Addendum No. 1

To:	All Plan Holders	**Project:**	Runway 1-19 Paving Project
Airport:	Granbury Regional Airport	**KSA Project No.:**	GY.012
Date:	October 27, 2021	**Client Project No.:**	2002GRANB

SHEET NO. 15R

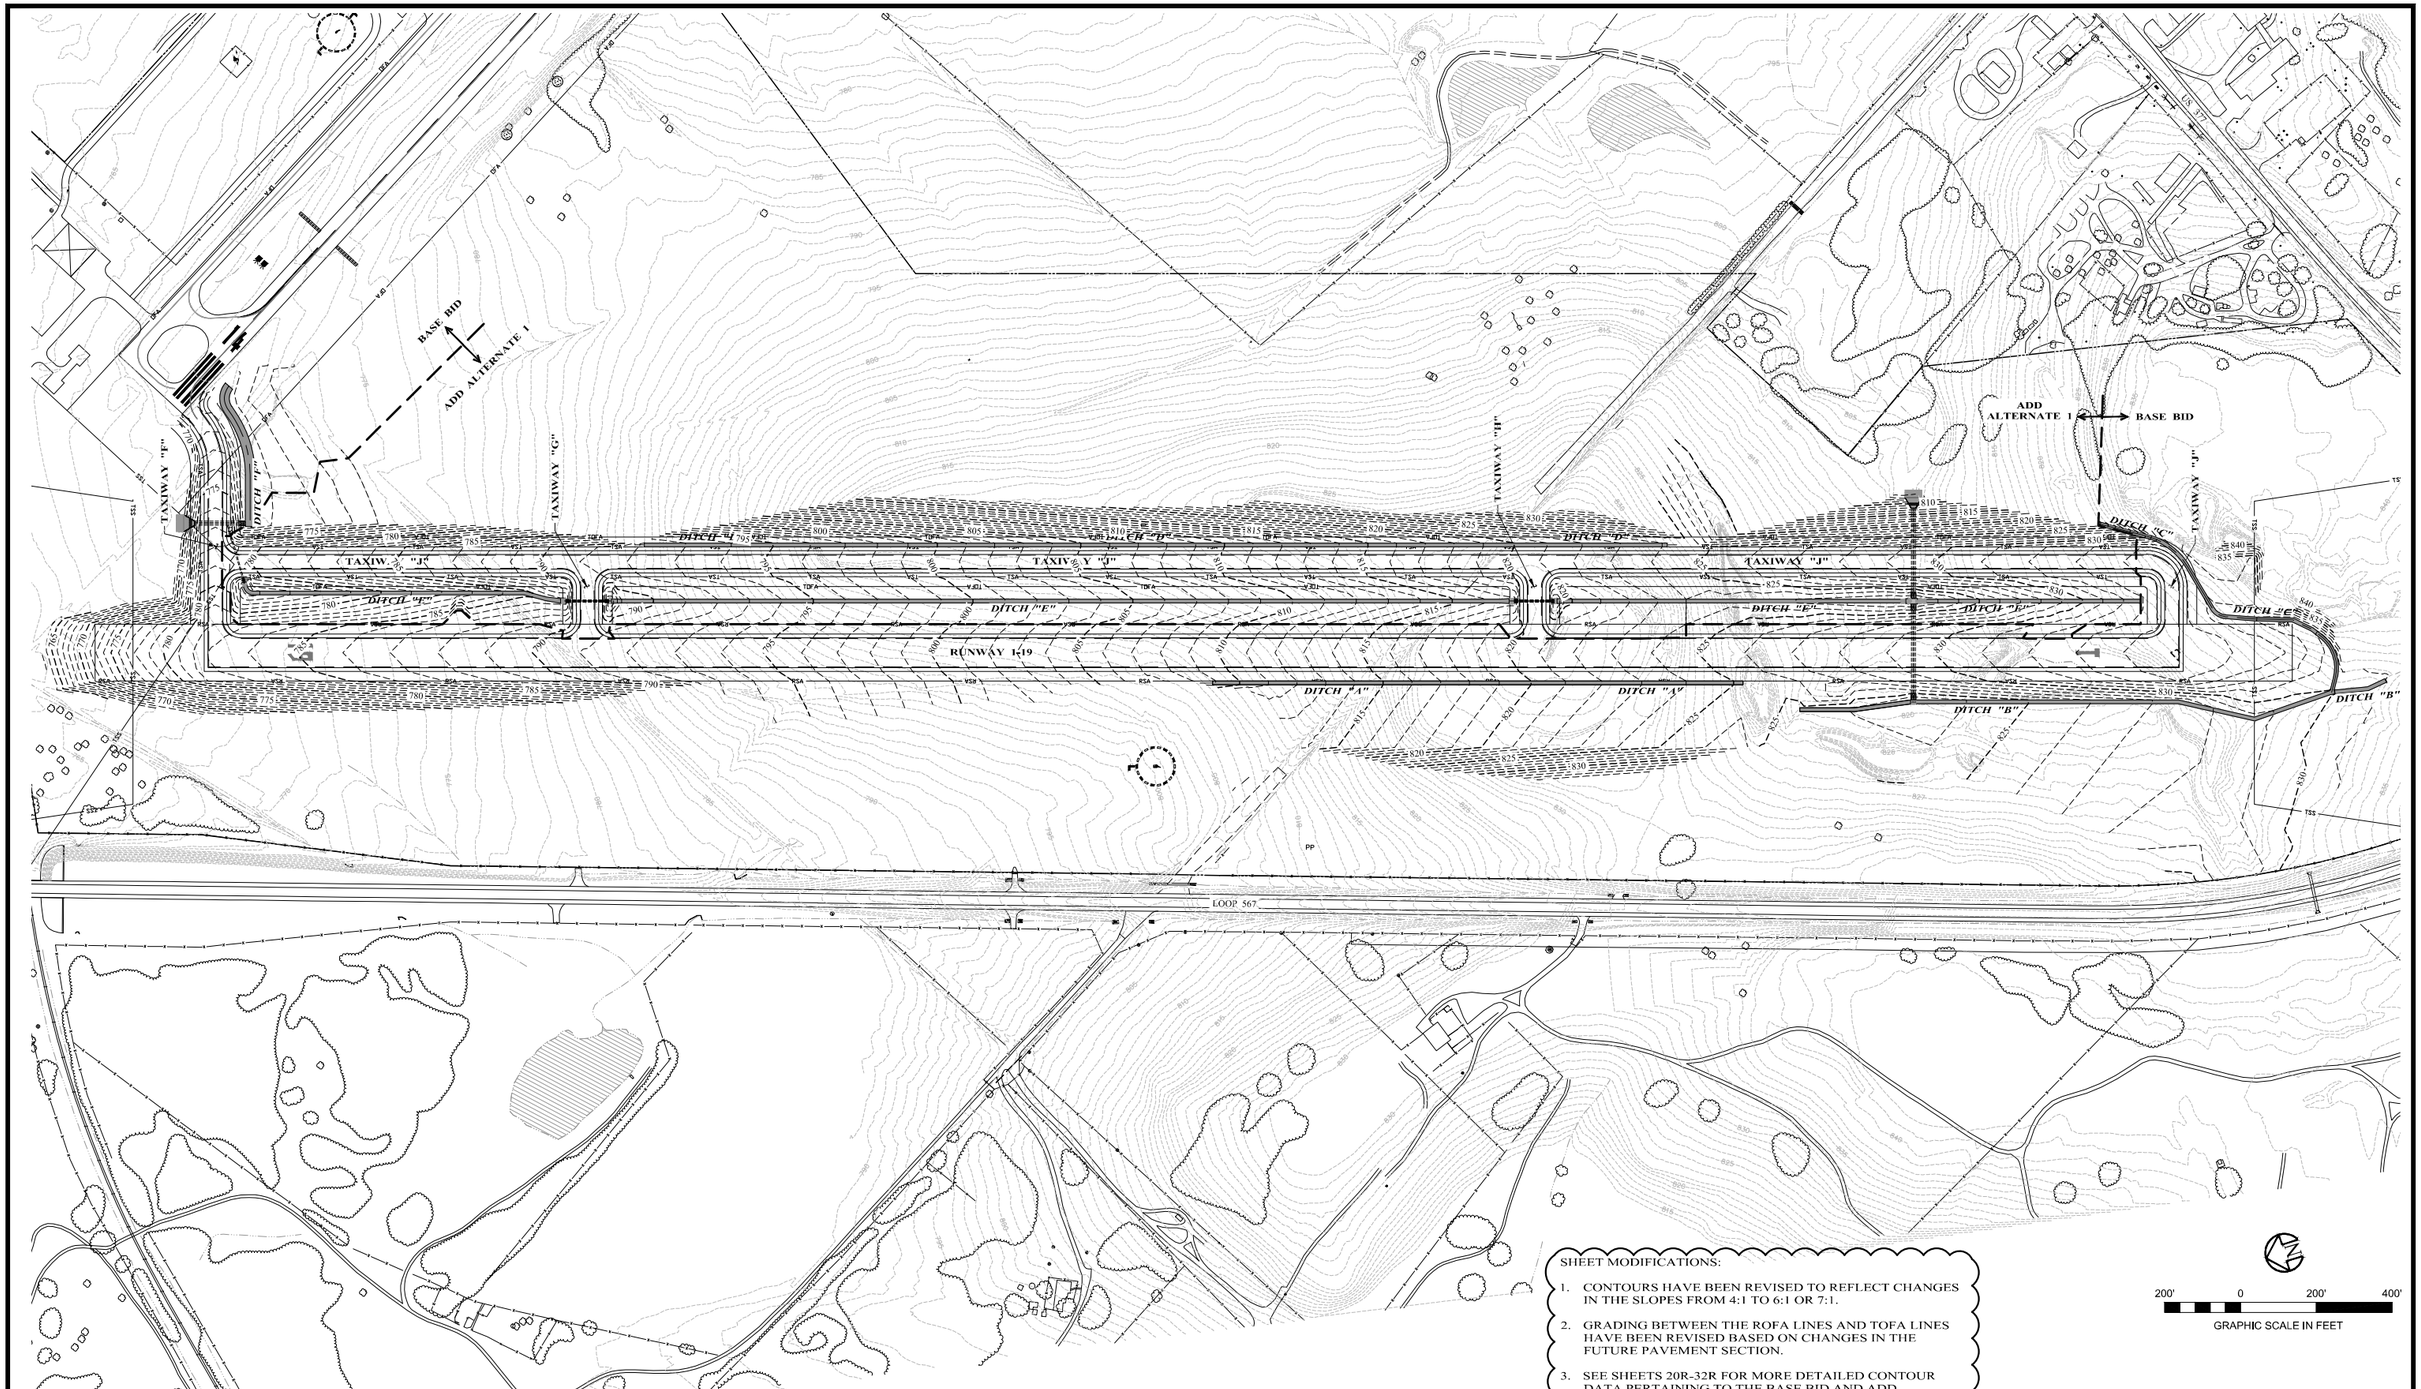
1. CONTOURS HAVE BEEN REVISED TO REFLECT CHANGES IN THE SLOPES FROM 4:1 TO 6:1 OR 7:1.
2. GRADING BETWEEN THE ROFA LINES AND TOFA LINES HAVE BEEN REVISED BASED ON CHANGES IN THE FUTURE PAVEMENT SECTION.
3. SEE SHEETS 20R-32R FOR MORE DETAILED CONTOUR DATA PERTAINING TO THE BASE BID AND ADD ALTERNATE CONSTRUCTION.
4. SEE SHEETS 33R-43R FOR REVISED CROSS SECTION DATA.
